HIDALGO COUNTY  
URBAN COUNTY PROGRAM

UCP CONTRACT CHANGE ORDER REQUEST

<p>CITY/PCT: Hidalgo County Precinct No. 1 1902 Joe Stephens Ave. Ste. 101 Weslaco, TX 78599</p> <p>Phone #: (956) 968-8733</p>	<p>DATE: May 11, 2016</p> <p>CHANGE ORDER NO. 1</p>
<p>CONTRACTOR/FIRM Texas Cordia Construction, LLC 3149-A Center Pointe Drive Edinburg, TX 78539</p> <p>Phone #: (956) 627-6181</p>	<p>PROJECT/NAME/ACCT. NO.  Hidalgo County Precinct No. 1 Street Improvements to: Old L a Blanca Road (Mile 10-12) Phase 2</p> <p>5013/14/15-91-0311-5000-9100- UCP-ML</p>
<p>You are hereby requested to comply with the following changes from the contract plans and specifications: This change order is due to additional culverts due to existing culverts not being reinforced, replacement of a leaking irrigation line under the roadway, and the alignment of the proposed roadway connecting to Mile 12 directly in lieu of a curve. The total additional time needed to complete the project is <u>10</u> days and will be added to the contract time.</p>

ROADWAY COUNTY PCT NO. 1  
 OLD LA BLANCA RD. PHASE 2  
 PAVING AND DRAINAGE IMPROVEMENTS  
 PLAN AND PROFILE - STA. 91+00 TO 101+00

HENKOLD COUNTY PCL PHASE 1  
 OLD LA BLANCA RD. PHASE 2  
 PAVING AND DRAINAGE IMPROVEMENTS  
 PLAN AND PROFILE - STA. 21+00 TO 31+00

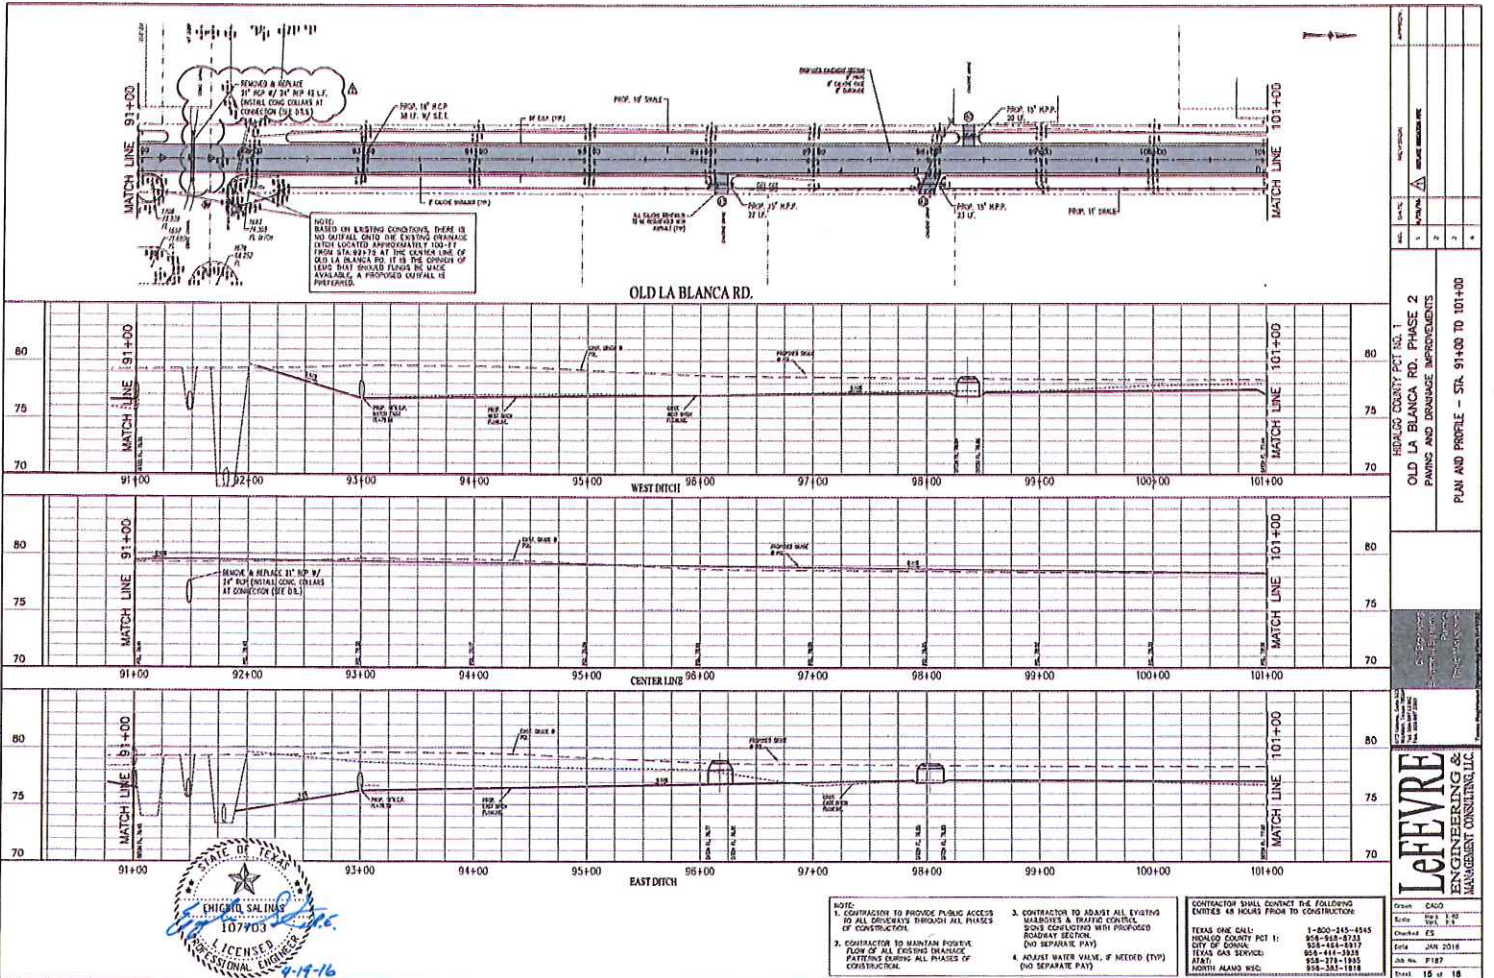
1. The existing culvert and grate inlet across Old La Blanca Rd. and Sioux Rd. do not have reinforcement and are damaged and not salvageable. The change order proposes to replace both items.
2. At Sta. 92+00 there is a 21-inch leaking irrigation line under the roadway that needs to be replaced.
3. The alignment of the proposed roadway connecting to Mile 12 will be revised to connect to the intersection directly in lieu of a curve. The curve is located outside the existing County ROW, and therefore, this area was revised.
